**SOIL, GEOLOGY, GEOLOGIC HAZARD STUDY  
FLYING HORSE NORTH  
FILING NO. 2  
EL PASO COUNTY, COLORADO**

March 8, 2022

**PUDSP234**

GEOLOGY/ENGINEERING GEOLOGY MAP  
 FLYING HORSE NORTH FILING NO. 2  
 EL PASO COUNTY, CO.  
 FOR: FLYING HORSE DEVELOPMENT, LLC

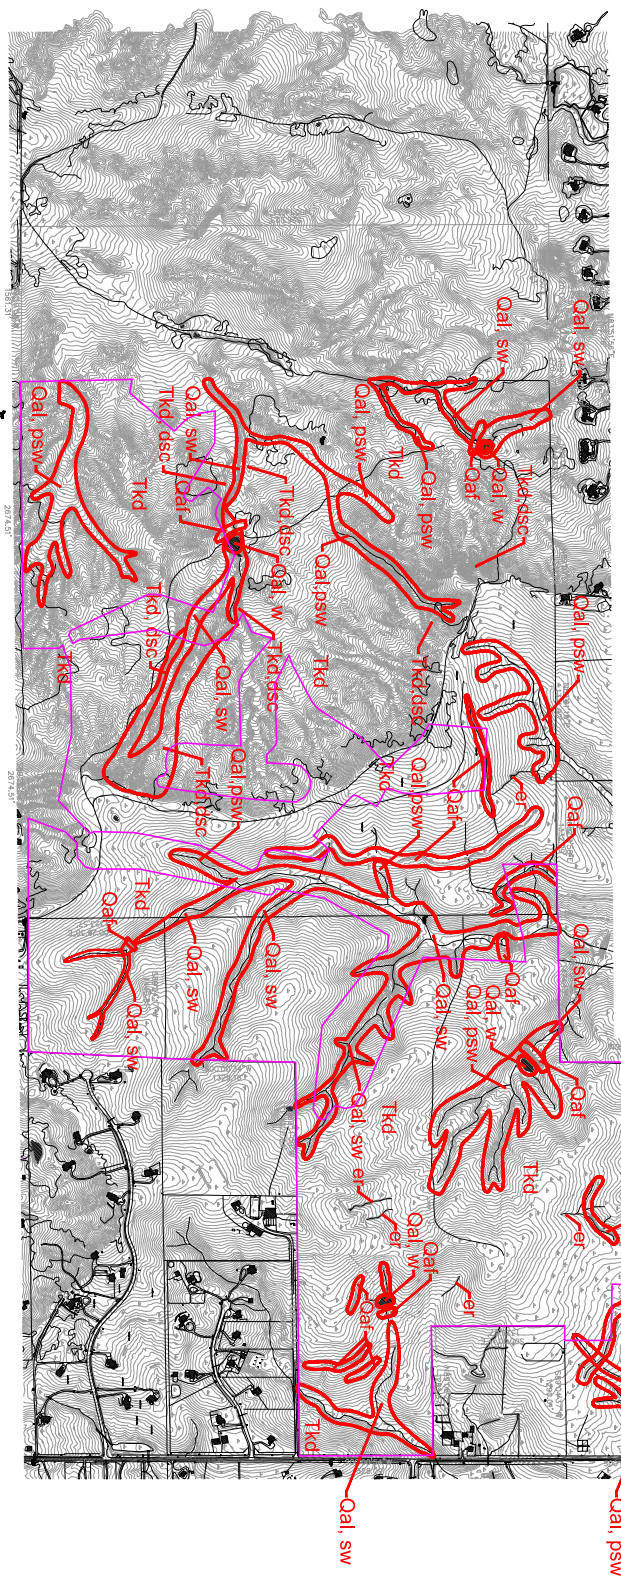
It is challenging to see how these correlate to the actual proposed lot layout without them overlaid over each other. The geologic hazards and constraints have with the proposed lot layout.
